February 19, 2021

**Addendum No. 1**

Contract No.: DA00495

*Southport Ferry Terminal Dock Replacement & Rip Rap*

EXISTING UTILITY  
 PIER FOR  
 SOUTHPORT  
 FERRY BASIN

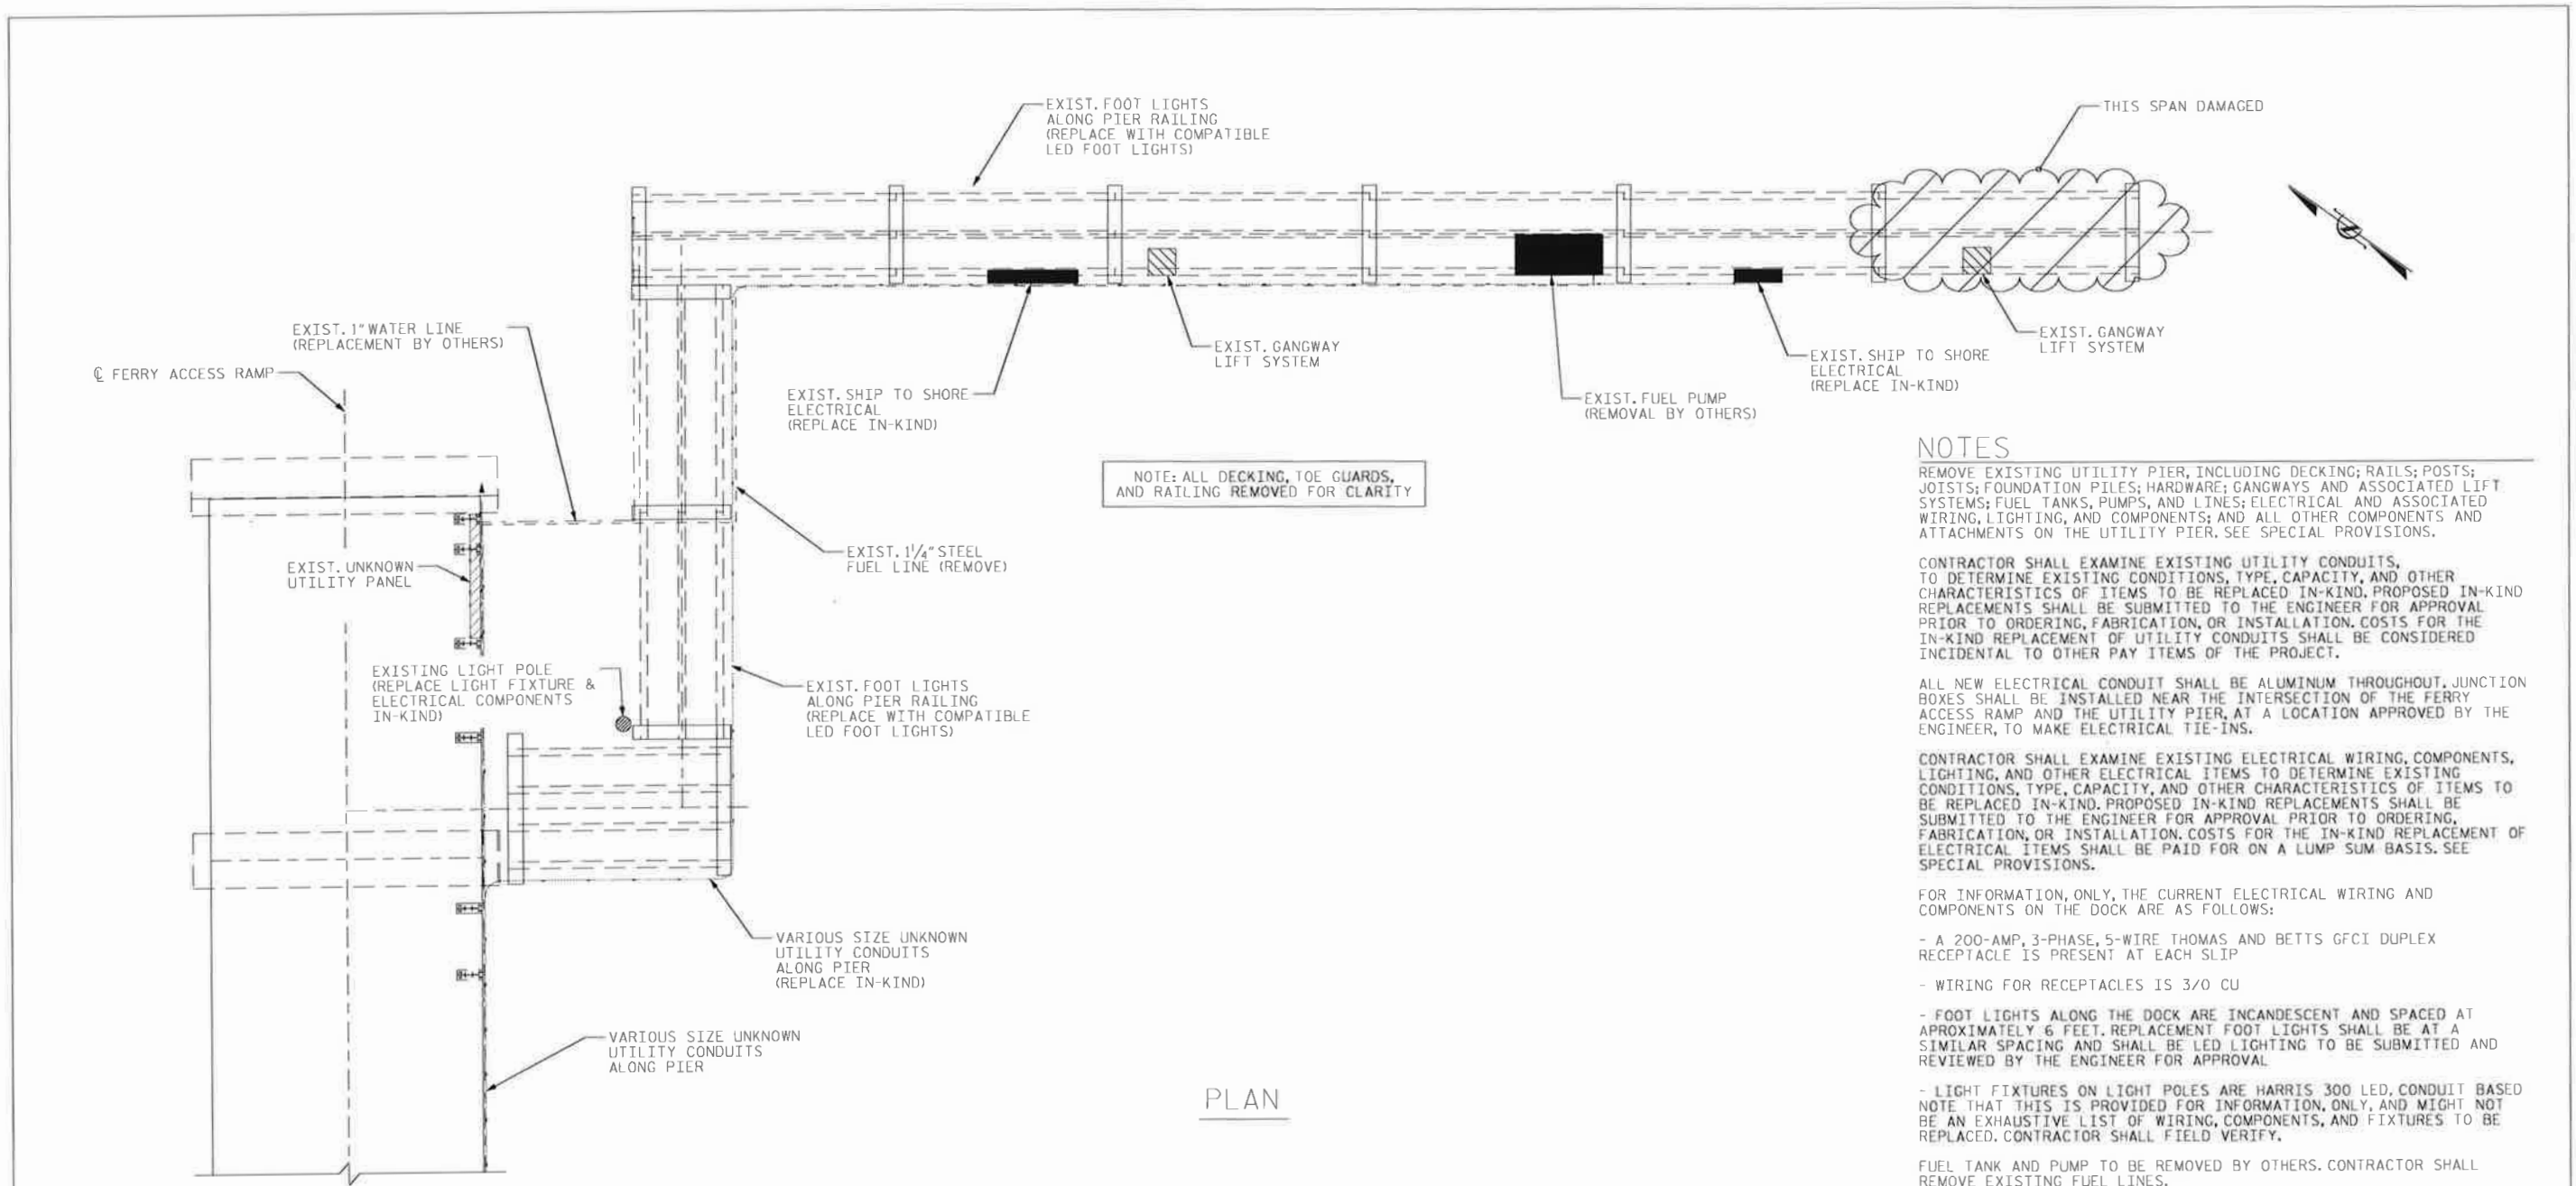
Plan Sheet 3, (S-01) “Existing Utility Pier For Southport Ferry Basin” has been revised to clarify the requirements of the electrical conduit. Please replace the original Plan Sheet 3, (S-01) “Existing Utility Pier For Southport Ferry Basin” with the attached revised Plan Sheet 3, (S-01) “Existing Utility Pier For Southport Ferry Basin”.

- ALL NEW ELECTRICAL CONDUIT SHALL BE ALUMINUM THROUGHOUT. JUNCTION BOXES SHALL BE INSTALLED NEAR THE INTERSECTION OF THE FERRY ACCESS RAMP AND THE UTILITY PIER, AT A LOCATION APPROVED BY THE ENGINEER, TO MAKE ELECTRICAL TIE-INS.
